Councillor Advice

Conceptual Stormwater Management System

**14 Claret Ash Avenue,
South Bowenfels NSW 2790**

Claret Ash Avenue Subdivision – Conceptual Stormwater Management Plan

Figure 1: Discharge Point Locations

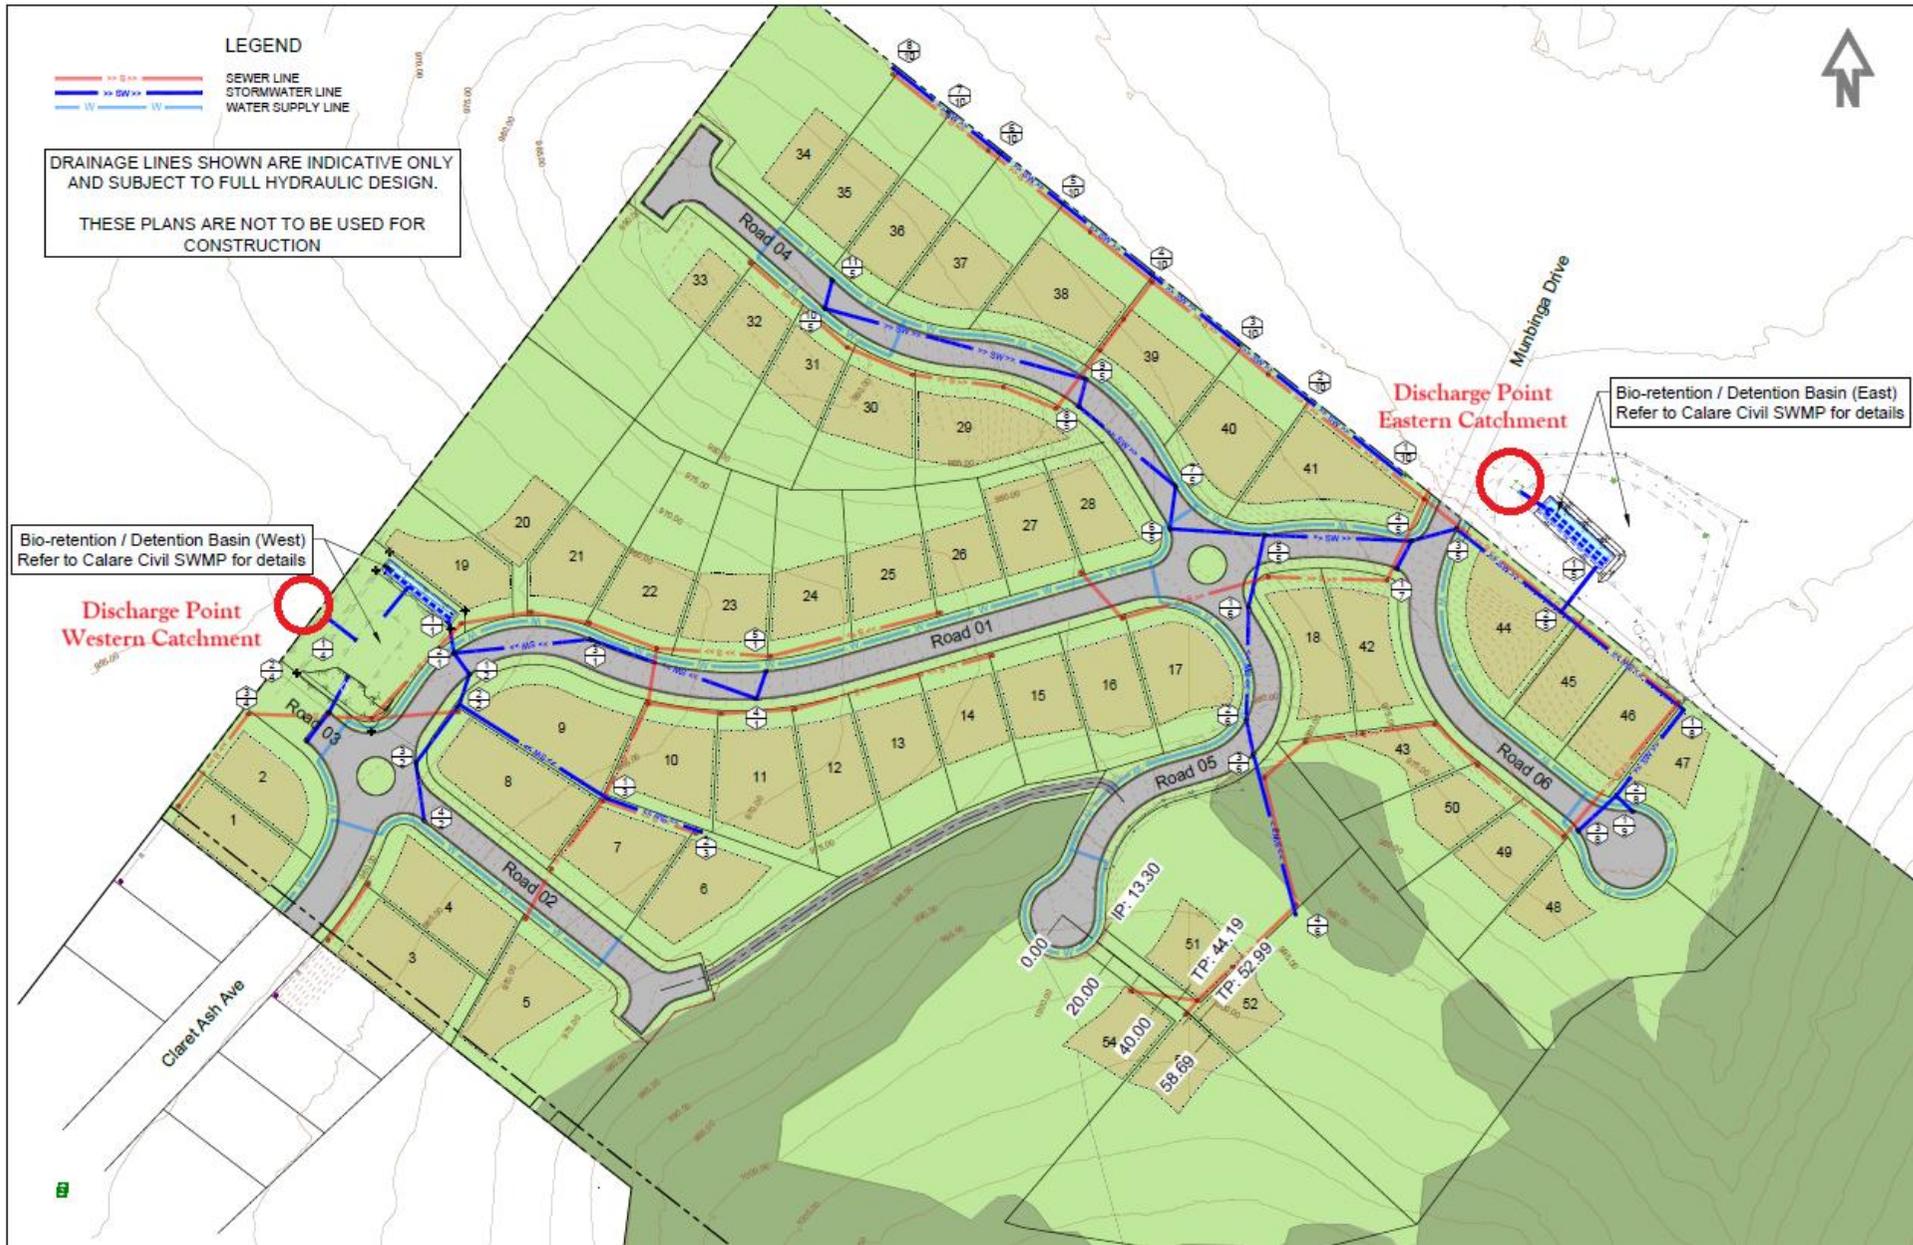
This represents a flow rate reduction between the scenario on-site today, and the scenario that will exist once the subdivision has been completed, including all bio-retention basins. The percentage reduction at the catchment outlet (highlighted on Figure 1 above) is expected to be:

In summary, during the most frequent rainfall event (1 in 5-year event), flow rates at the outlet of the detention basin will be reduced by 60% compared to a pre-development scenario. During the most irregular, but highest intensity event (1 in 100-year event), flow rates at the outlet will be reduced by 76%.

It is important that this analysis consider flow rate as it is the rate of flow over a given time that determines whether the pipe that runs under the Great Western Highway will reach capacity, and the extent to which any water will pond at the inlet of the existing highway pipe before discharging towards Col Drewe Drive.

Noting that discharge flow rates are expected to dramatically decrease, so will the ponding that occurs today at the inlet of the existing 400mm stormwater pipe under the Great Western Highway.

Figure 2: Proposed modifications to nearby infrastructure

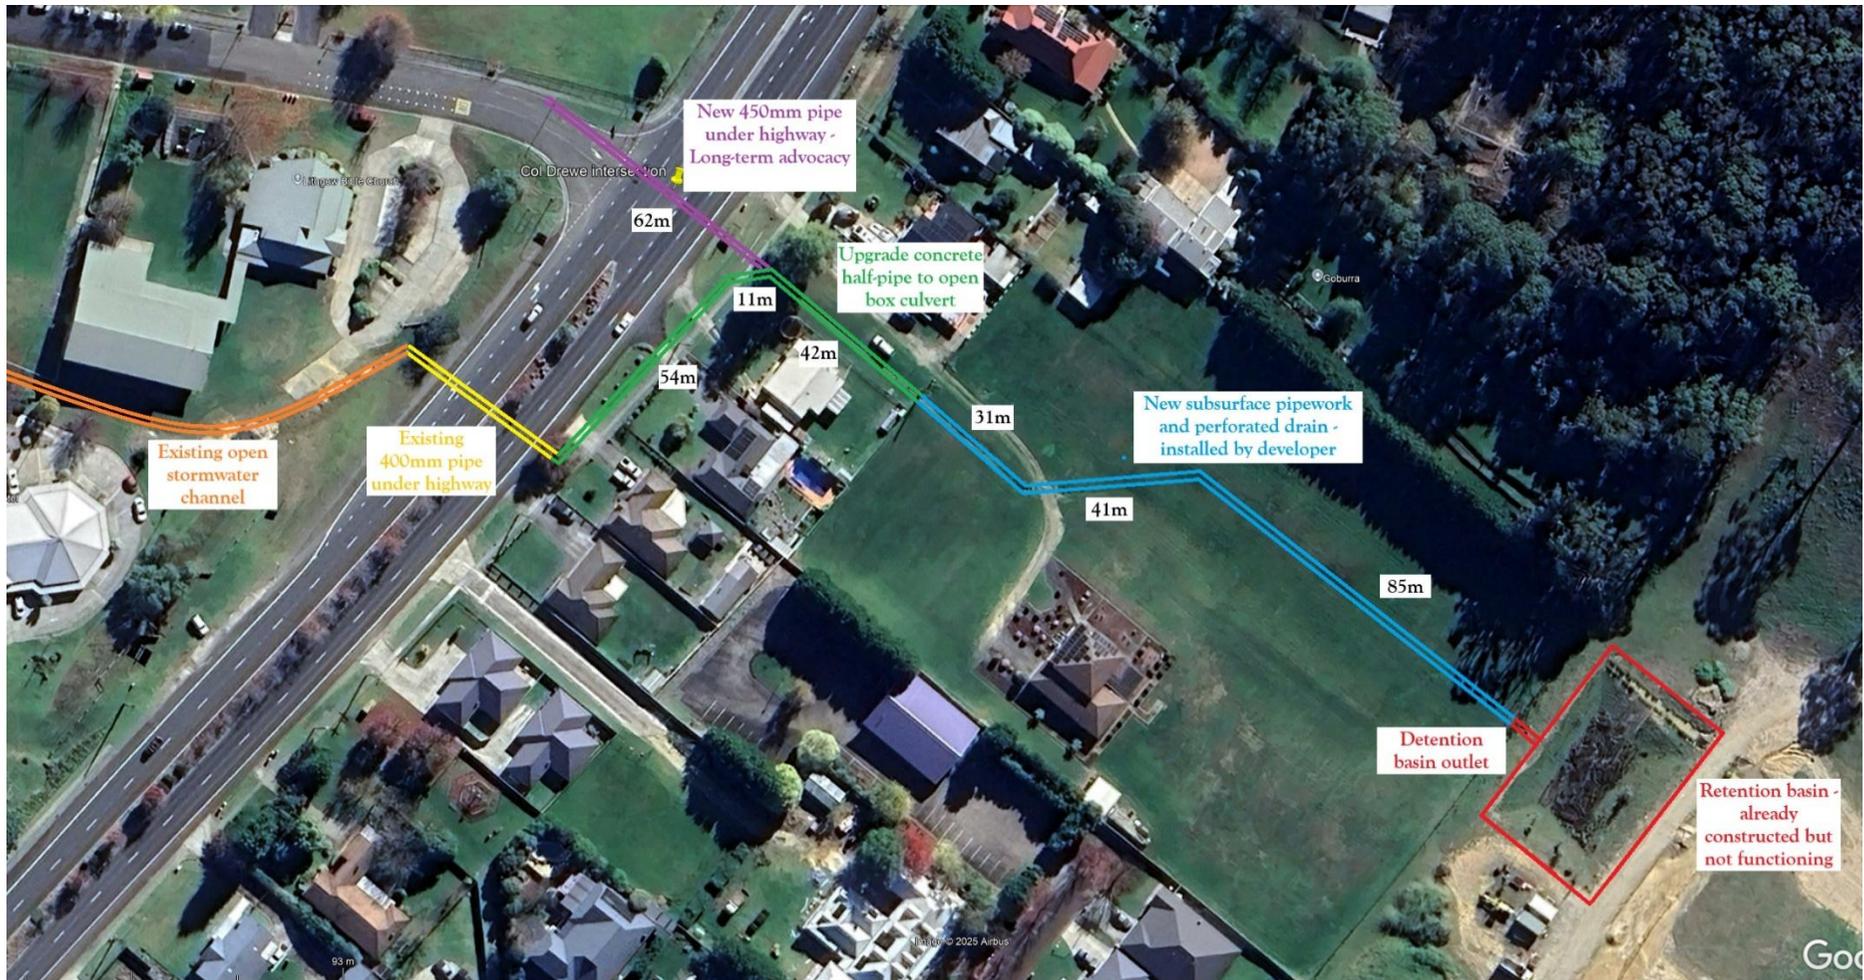
The proposed modifications to nearby stormwater infrastructure is depicted in Figure 2 above, but explained below.

The developer has agreed to the installation of approximately 157 lineal metres of 250mm pipe (matching the outlet of the detention basin) to the northwestern boundary of the Taylor's property.

The alignment of the blue line is the wettest part of the Taylor's property. Hence, alongside the 250mm pipe, a smaller 100mm perforated pipe to be installed to catch groundwater and assist with the drying of the resident's property.

An upgrade of the concrete half-pipes in these locations require upgrade/amplification for the full length of approximately 107 metres. They are approximately 300mm in size, a cross-sectional area of about 0.14m². It is proposed to upgrade these to something like a 1500mm x 300mm culvert, increasing the cross-sectional area to 0.45m² (3x the capacity of the current half-pipes).

It is proposed to keep these as open top culverts to ensure that we don't create capacity issues upstream. Lengths that carry stormwater underneath driveways will have an enclosed top. There are three driveways impacted.

These will then deposit into the 400mm pipe (yellow lines) that runs underneath the highway (approx. 0.5m² cross sectional area).

Previously, it has been suggested that the pipes under the highway (marked in yellow) require amplification. This would only serve to increase the risk of flooding around the church, Medical Centre and motel. Instead, it is proposed that Council commence advocacy to install a new pipeline under the highway as shown in purple on the map above, over a length of 62 metres.

- a) Obtain quotes from local companies to construct the new culvert/channel indicated in green within Figure 2.
- b) Commence negotiation with the developer to reach an agreement regarding cost-sharing.
- c) Depending on the outcome of those negotiations, consider a funding source from the 2025/26 operational plan.
- d) Once complete, call an extra-ordinary meeting of the Infrastructure Committee to discuss and agree on a solution and funding proposal, for consideration at an Ordinary Meeting of Council.
